CHASSIS TECH TIPS

2011MY Improper Body U-Bolt installation on right side, near fuel lines

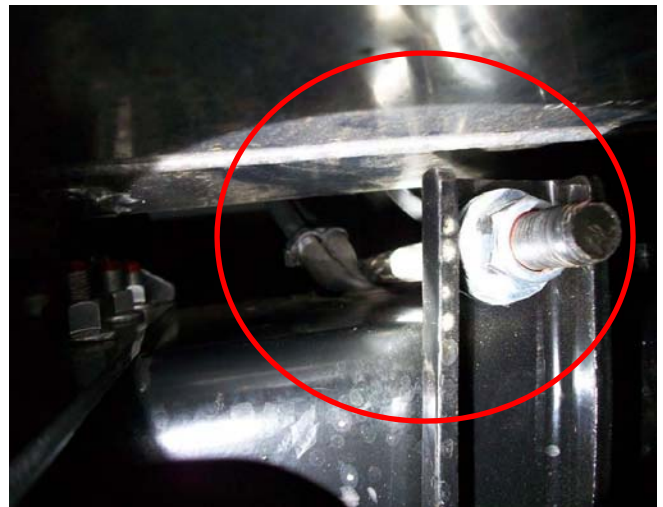
To prevent fuel line collapse caused by an incorrect U-bolt location make sure to locate the U-bolt as shown below, through the harness loop of junction box.

Example of incorrect U-bolt location-between outside frame rail & fuel tank causing collapse of fuel line when placed here.

Example of correct U-bolt location –
inside frame rail.

Proper U-bolt location
